From: Christopher Davies <Christopher.Davies@crawco.co.uk>
Sent: 19 July 2023 15:47
To: Subsidence <subsidence@crawco.co.uk>
Cc: MWA Arboriculture Office <Office@mwaarboriculture.co.uk>
Subject: SU2206135 - RE: S211 - HGY/2023/1685 - 154 Morley Avenue N22 - SU2206135

SU2206135 LA want additional info S211 Cypress tree

Photos of the damage not included within reports:

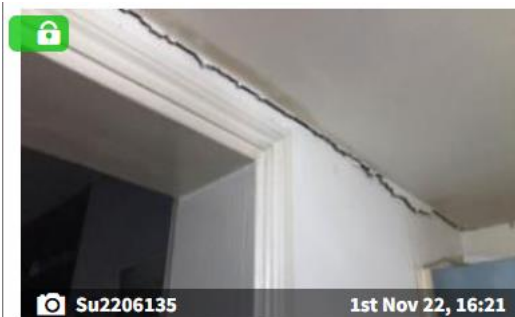
- No BRE classification is given or photographs showing the cracks
